Proposal for a new supplement to UN Regulation No. 85

Submitted by the experts from France.

The text reproduced below was prepared by the expert from France. This document proposes to allow higher tolerance for pressure measurement in paras 4.7 and 4.8 to Annex 5. The difference introduced in revision 1 of the document are in **red**.

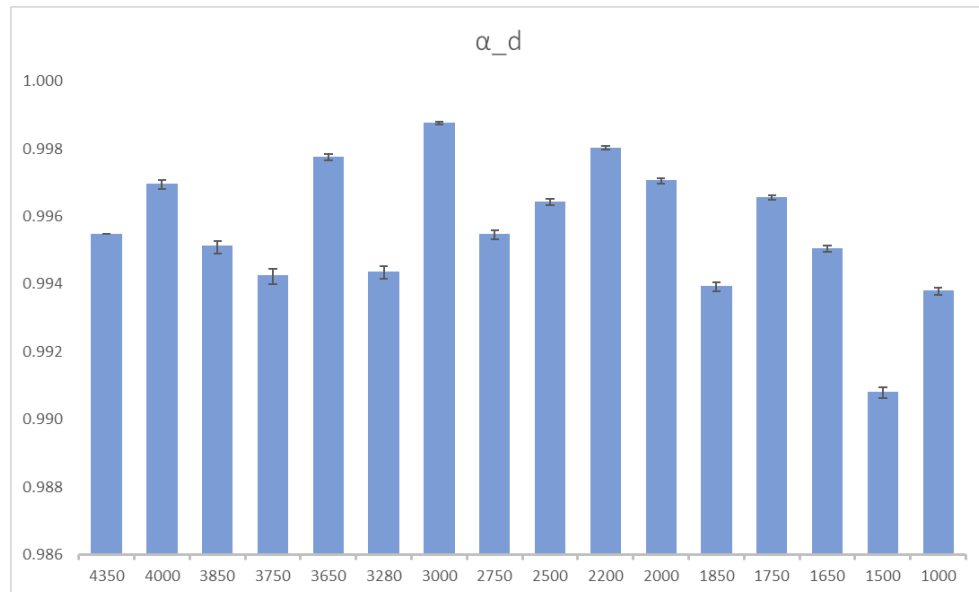
Pressure accuracy is not always compliant to the requirement in § 4 in the engine test benches.

Evaluation of the impact on the pressure sensor accuracy at the intake (fictive engine) with ±800 ~~mbar:~~ Pa

Allow higher tolerance for pressure measurement in §4.7 and 4.8 (+ aligned intake and exhaust) in order to avoid refusal of test due to the non-compliance of pressure accuracy and based on the low impact on the α_d . Value or approach (linearity?) to be discussed.
